RE: SUBMISSION TO SSD-81623209 FOR RESIDENTIAL FLAT BUILDING WITH IN-FILL AFFORDABLE HOUSING AT 9-21 BEACONSFIELD PARADE, LINDFIELD

Ku-ring-gai Council's objection to SSD-81623209 at 9-21 Beaconsfield Parade, Lindfield

Figure 3: Applicant's GFA calculation, ground level Building 3

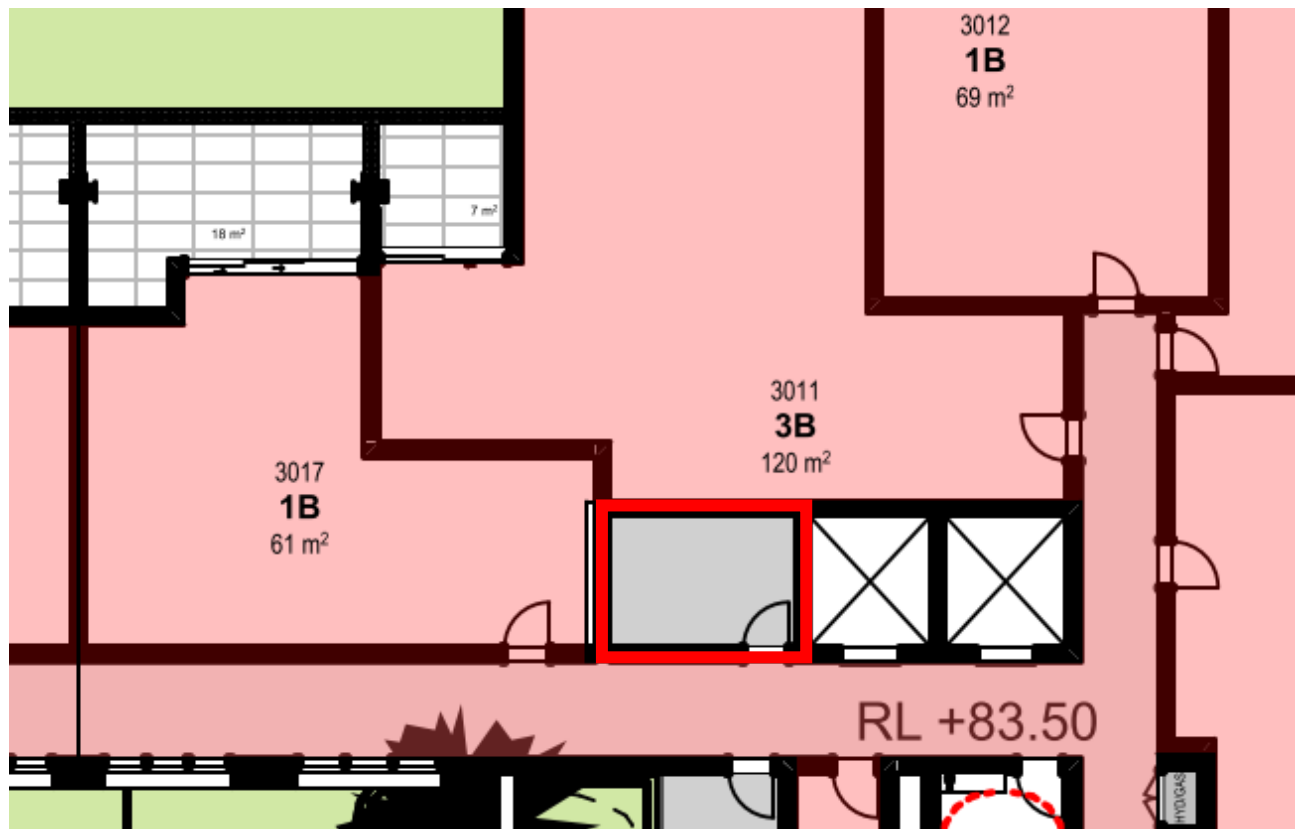
The room adjacent to the lifts on levels ground, 01 and 02 of Building 3 have been excluded from the Applicant's GFA calculation but the use of these rooms has not been identified (**Figure 3**).

The consent authority needs to carefully review the Applicant's GFA calculations to ensure compliance with the maximum permitted FSR.

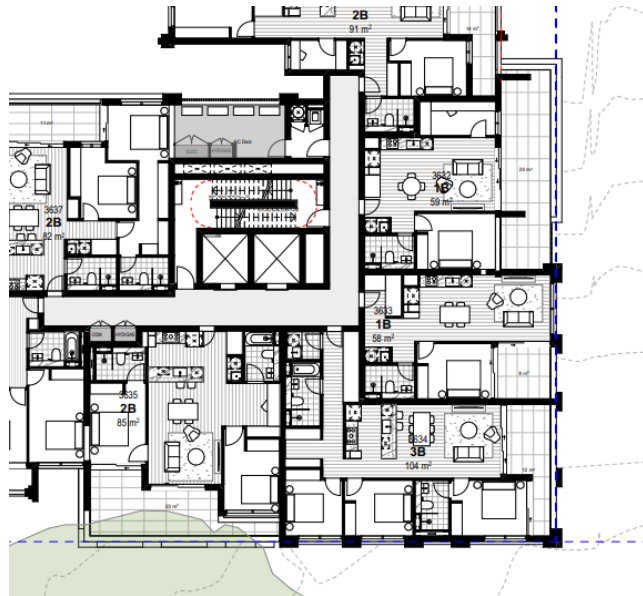
Building 3 (SE corner, Level 6):
Apartments 3633 and 3634 appear only 6–7m from the boundary, short of the required 9m.

(Blue line appears to align with the 6m boundary).

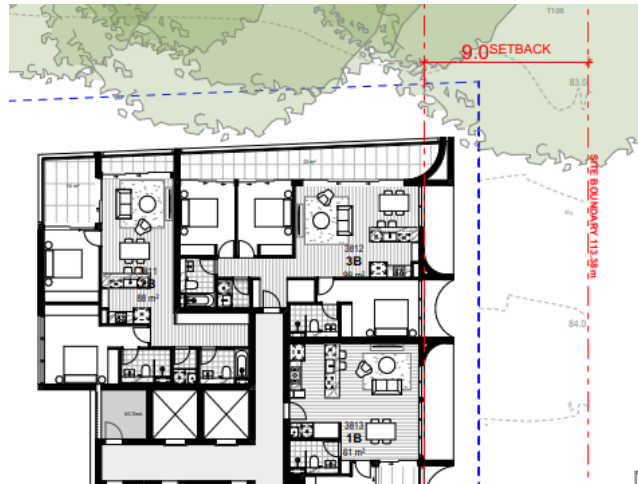
Building 3 (north section, Level 8):
Reaches nine storeys, but provides only 9m where 12m is required.

(Red line is 9m setback).

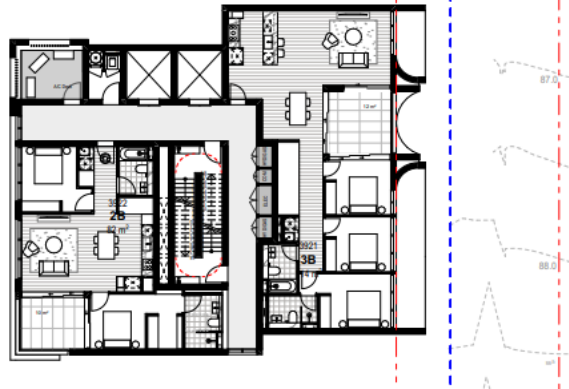
Central section of Building 3 (Level 9):
Reaches nine storeys with only a 9m separation, below the 12m standard.

(Red line is 9m setback).

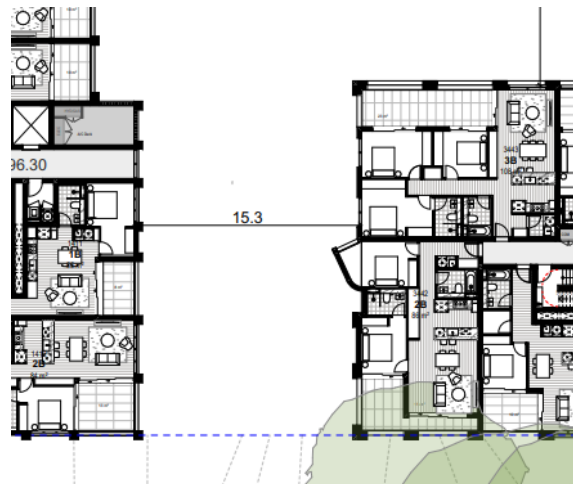
Between Buildings 1 and 3 (Levels 4–8):
Requires 18m between habitable rooms; Level 4 provides 15.3m, Level 5 provides 16.5m.

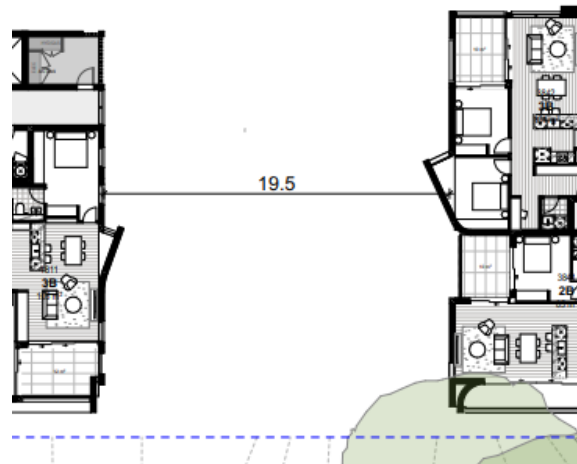
Level 8 (Buildings 1 and 3): At nine storeys, 24m is required, but only 19.5m is provided.

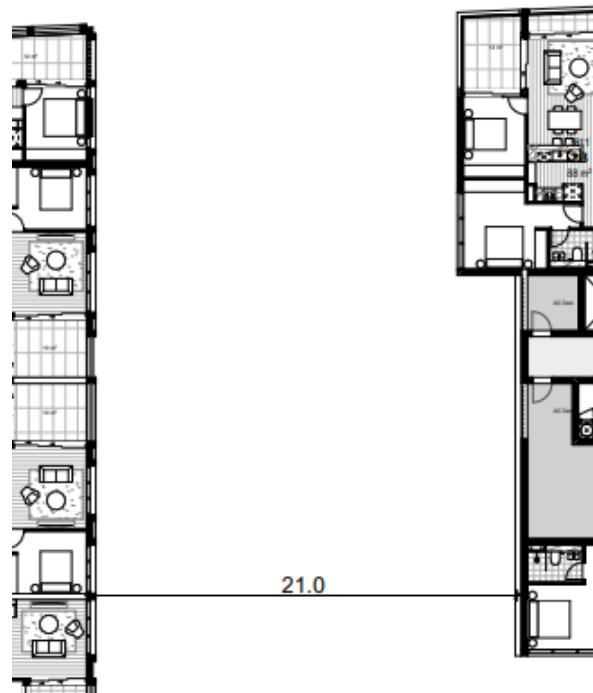
Between Buildings 2 and 3 (Level 8, NE side): Requires 24m; stated as 21m, but accounting for the building's step-back, it's estimated to be closer to 18m.

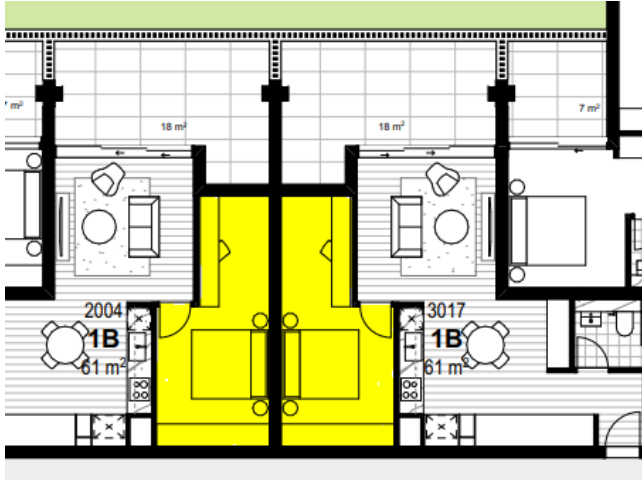
The ADG requires that all habitable rooms must have a window in an external wall. While the proposal claims compliance, this is not accurate. Apartments 2004 and 3017 appear to include bedrooms without external windows, relying instead on internal openings.

This does not meet the ADG requirement, as borrowed light or ventilation does not qualify. It directly impacts internal amenity and cannot be justified as a variation. The design should be revised to ensure full compliance.

Internal bedrooms in units 2004 and 3017 don't have windows.

Image 1:

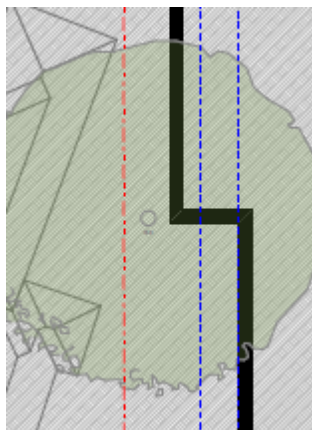
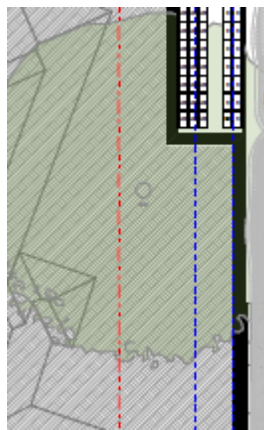
Tree 62 is a mature *Syzygium australe* (Bush Cherry) with 16m x 14m spread located adjacent to the western site boundary. The tree is in good health and condition providing valuable amenity between properties.

Submitted plans differ as to the location of the basement and proposed construction works. As such the arboricultural impact assessment report cannot be relied upon and there is no certainty or clarity of impact outcomes.

No root mapping has been undertaken, and the inconsistency in development plans results in inconsistency with Item 14 of SEARS.

For certainty and clarity and to enable assessment of impact, the location of the tree in proximity to bulk excavation and construction works needs to be clarified and submitted plans be consistent.

Figure 9: Participation of proposed development in views from the heritage item, plan. Two Green cones would remain open to views. The Blue cone is blocked by the proposed development.

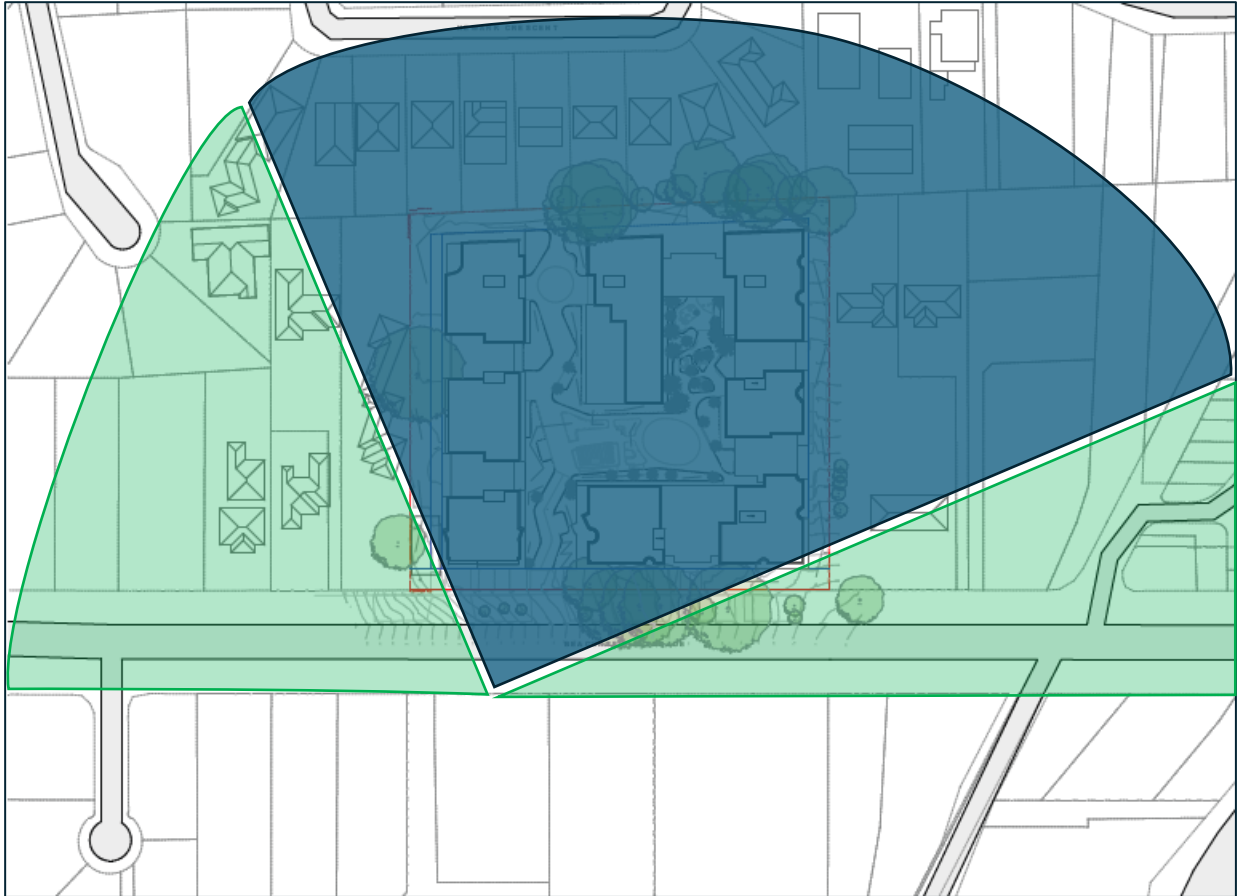
The new development be 30m away from the heritage item at 14 Beaconsfield Parade, present in a view cone from the heritage item to the North-East, North and North-West (**Figure 9**) It would be about 30m high, with a frontage over 100m wide, and on higher grounds than the item.

Looking from the heritage item at 14 Beaconsfield Parade, the new development would dominate or interrupt views to the North and North-West.

In vertical section, views from the heritage item at 14 Beaconsfield Parade would be dominated by the new development up to 60 degrees from the horizontal line (refer to **Figure 10**).

Figure 11: Encroachment of the proposed development on front setback defined by adjoining houses. Red line connects front setbacks of two adjoining properties and demonstrates degree of intrusion.

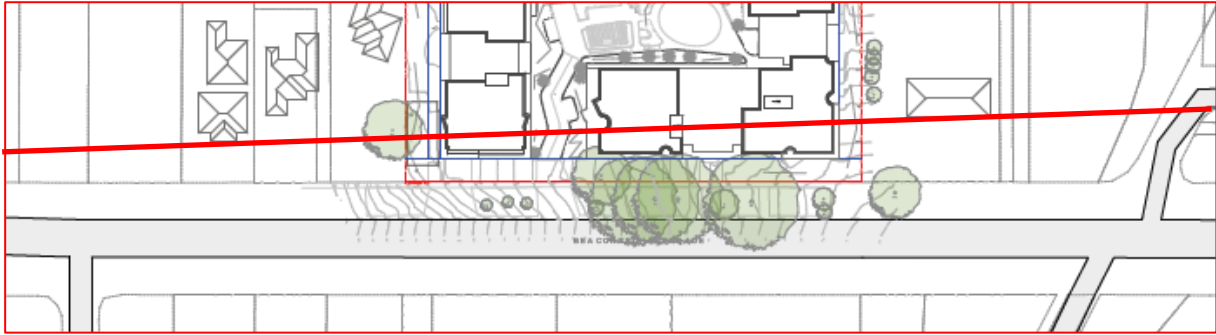
The proposed building would encroach on the established pattern of front setbacks to Beaconsfield Parade, which is defined by adjoining houses. This would make it an imposing element, interrupting views along the street into the HCA and have a major adverse impact on the streetscape views (refer to **Figure 10**). The side setbacks are not sufficient to allow screening planting.
